DEVELOPMENT ASSESSMENT PANEL REPORT	
Application No.	DA/2024/0330
Address	136 Percival Road STANMORE
Proposal	Alterations and additions to a shop top housing development including alterations and additions to the existing unit above the ground floor commercial building at the front of the site; demolition of the garage fronting the rear laneway; construction of a garage with 3 storey residential unit above; associated services, access walkways and landscaping
Date of Lodgement	9 May 2024
Applicant	Mike Devitt
Owner	Mike Devitt & Marianne C Piotrowski
Number of Submissions	18, including 2 submissions in support
Cost of works	\$921,000.00
Reason for determination at Planning Panel	Number of submissions
Main Issues	<ul style="list-style-type: none"> • Variation to FSR development standard • Heritage conservation • Visual & acoustic privacy • Community safety • Matters raised in submissions
Recommendation	Refusal

Attachment A	Reasons for refusal
Attachment B	Plans of proposed development
Attachment C	Section 4.6 Exception to Development Standards
Attachment D	Heritage Impact Statement
Attachment E	Draft conditions of consent in the event of approval by Panel

Figure 10: Amended elevation plans indicating the location of the existing building (coloured in grey, building 1) and the proposed three-storey addition (outlined in white, labelled as building 2) facing in a southerly orientation towards no. 140

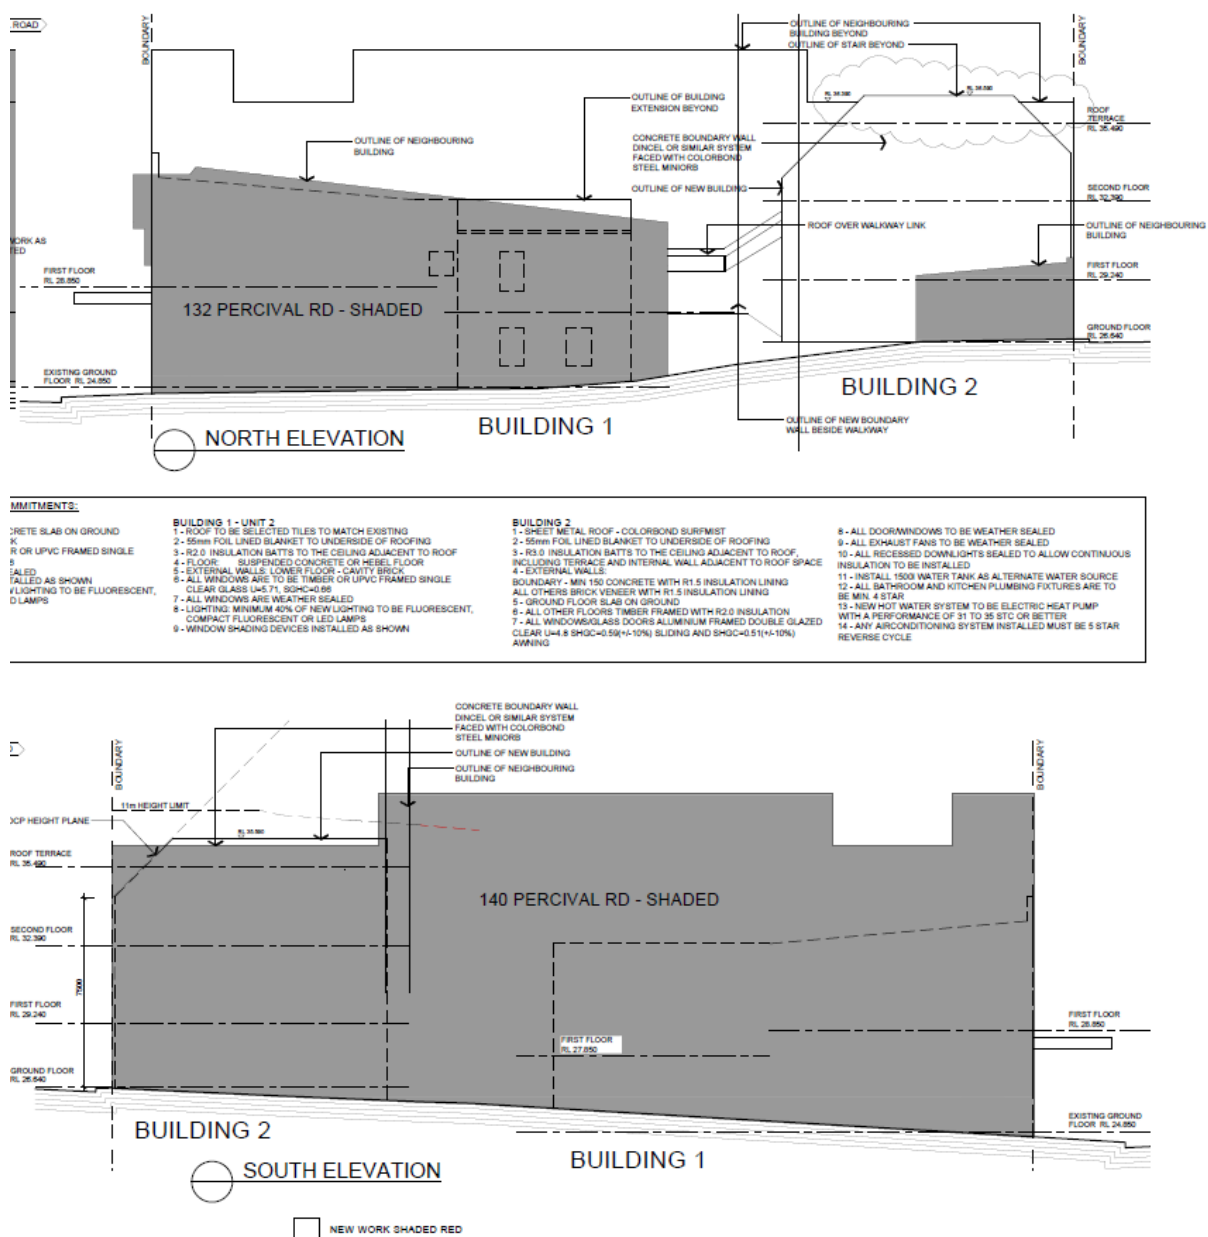
The views of the Sydney skyline and the Sydney Harbour Bridge in question originally would have been affected (as demonstrated in Figures 8 above) for the COS, due to the height of the ridgeline and balustrades for the rear unit. The height of the development has since been reduced following on from Council's Request for Additional Information, which requested for the height of the development to be lowered to maintain view sharing from this property. Following on from the plans being amended by the applicant, the view of the Sydney skyline and the Sydney Harbour Bridge would not be completely lost as a result of the proposed development, as demonstrated in Figure 10 below with a small portion of the roof still above the balustrade height adjoining the communal open space.

As discussed throughout this report, the amended plans received as part of the Request for Further Information letter reduced the bulk of the additions by lowering the access to the rooftop terrace to avoid protruding above the balustrade height for the COS area at no. 140. Whilst the height of the balustrade along the southern boundary of the rooftop terrace marginally encroaches above this adjoining balustrade, the encroachment is unlikely to result in any major view loss for no. 140.

Figure 11: View Loss Assessment indicating the direction and location in which the views are obtained from the communal open space area at No. 140

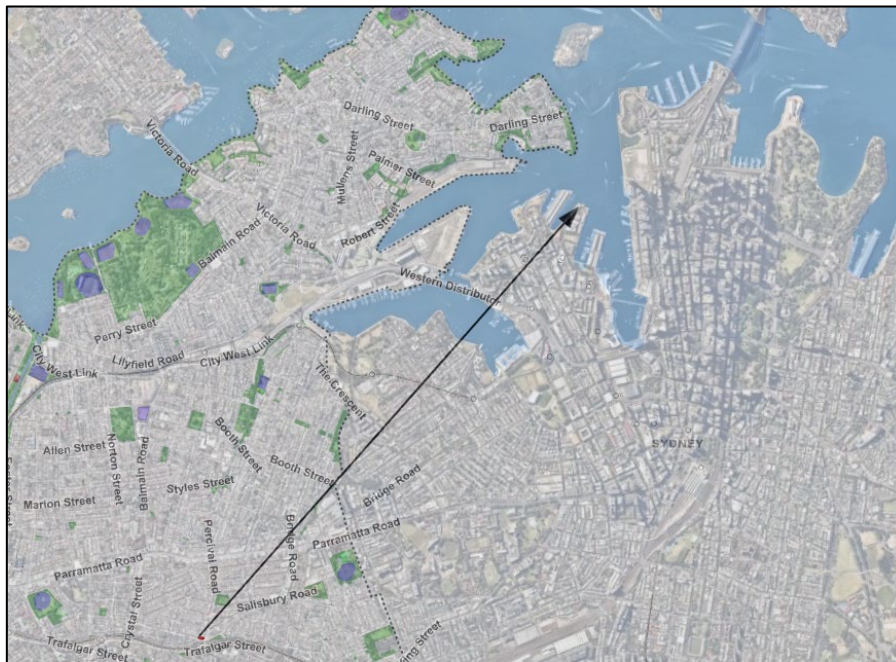
The views of the Sydney skyline from the COS area at no. 140 are enjoyed from the rear elevation looking north-east across the side boundaries of multiple properties, including that of the subject site. The views are obtained from a standing position and when looking in a north-easterly direction from the rear of the property (as shown in Figure 11 below).

Given the views from the COS area are obtained across multiple properties, any view corridors, even if considered highly valued, would be difficult to protect. As the views from the POS area of unit 11 at no. 140 are from the front of the site, it would be considered more reasonable for such views to be protected if they were obstructed.

Figure 11: View Loss Assessment indicating the direction and location in which the views are obtained from the private open space area of unit 11 at No. 140

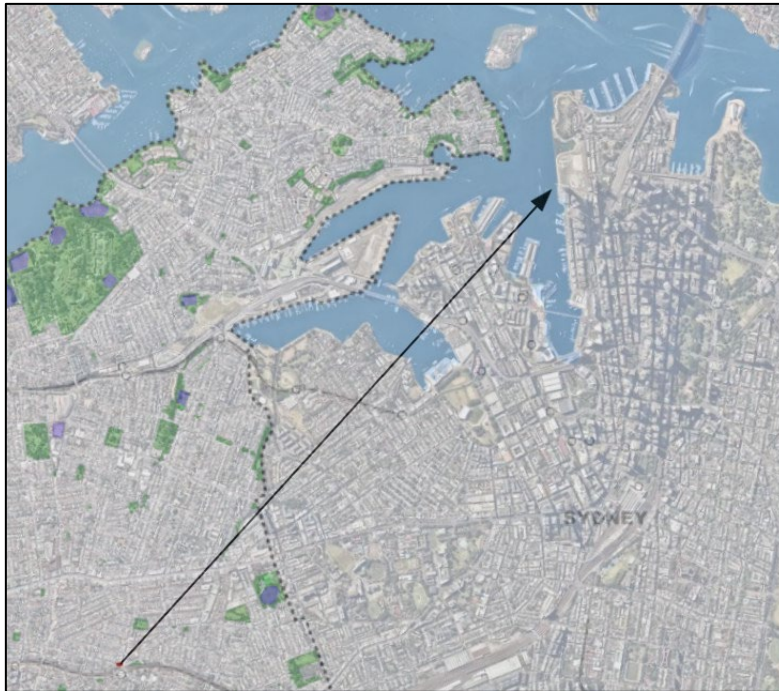
The views of the Sydney skyline from the POS area of unit 11 at no. 140 are enjoyed from the front elevation looking north-east, generally looking across Salisbury Road towards the city skyline. The views are obtained from a standing position from the portion of the POS which directly adjoins the principal living area, looking in a north-easterly direction from the front of the property (as shown in Figure 12 below).

As outlined above, the views in question are from the COS area and the POS area of unit 11 at no. 140. The views of the Sydney skyline are iconic; however, the views of the Sydney Harbour Bridge are only partial views of an iconic landmark that are viewed across multiple side adjoining properties. As demonstrated in Figures 10 and 11 above, the views of both the Sydney skyline and the Sydney Harbour Bridge will be maintained and unaffected from the POS area of unit 11 at no. 140, whilst the views from the COS at the rear of the building will be largely retained as a result of the revised development. Therefore, the proposal will have minor view loss impacts to the COS and no impact to the POS of Unit 11.

Figure 49 – Revised proposed new building rear laneway facing elevation with scale reduced (Source: HPA Architects)

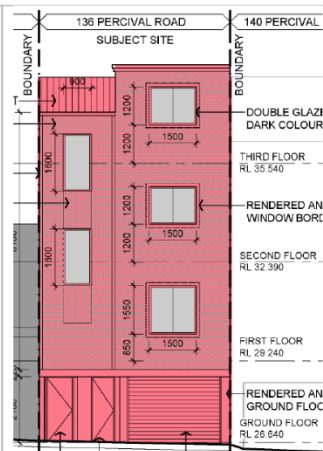
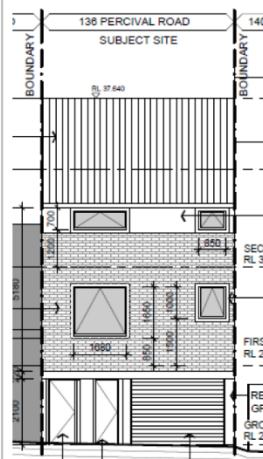
4. New building (as part of the shop top housing development) and garage fronting Percival Lane West.	<p>The proposal includes construction of a three-storey new building (as part of the shop top housing development) with a roof-top terrace above at the rear of the site fronting Percival Lane West.</p> <p>This will involve demolition of the existing single-storey garage structure fronting the laneway. This structure was constructed c.1970s and its removal will not involve intervention with early fabric.</p> <p>Due to its proposed siting at the rear of property, the new building (as part of the shop top housing development) will not be visible from the site's primary frontage on Percival Road and will have no impact on its streetscape.</p> <p>The extent, scale and form of the proposed new building have all been revised in response to Pre-DA advice from council as per the below figures. This included removing the originally proposed fourth floor, which has reduced the overall scale of the proposed structure with the maximum height reduced by approximately 1.0m.</p>	Moderate

Figure 51 Revised proposed new building northern elevation (Source: HPA Architects)

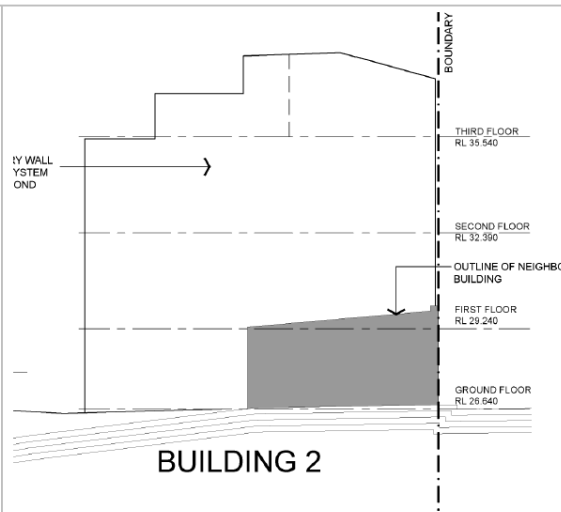
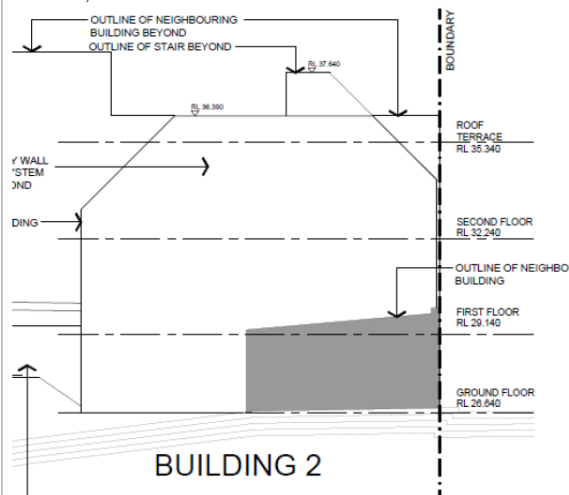
The eastern side of Percival Lane West contains several two storey structures to the north of the subject site (128, 126 & 124 Percival Road) with a four-storey structure (140 Percival Road) immediately to the south. The proposed three-storey structure will feature a flat roof used as a rooftop terrace, minimising the overall scale of the structure. Although the proposed three-storey structure will be taller than the adjacent two-storey rear lane fronting structures (to the north) it will be set lower than the overall height of the adjacent four-storey structure. The rooftop stairwell structure will exceed the height of the rear sections of 140
